Appl. No. 10/713,353 Amdt. dated March 14, 2006 Reply to Office Action of December 15, 2005

Amendments to the Drawings:

REMARKS

FIG. 2

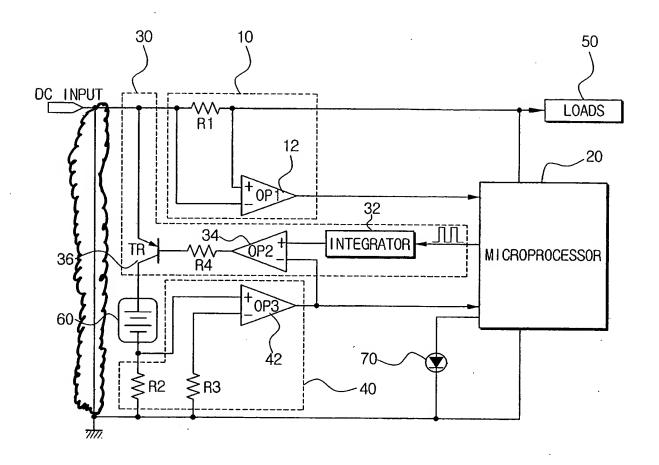
The attached sheets of drawings include changes to Figs. 2-4. These sheets replace the original sheets including Figs. 2-4. In Figure 2, the electrical connection directly shunting the DC INPUT to ground has been eliminated. In Figures 3 and 4, several typographical errors have been corrected.
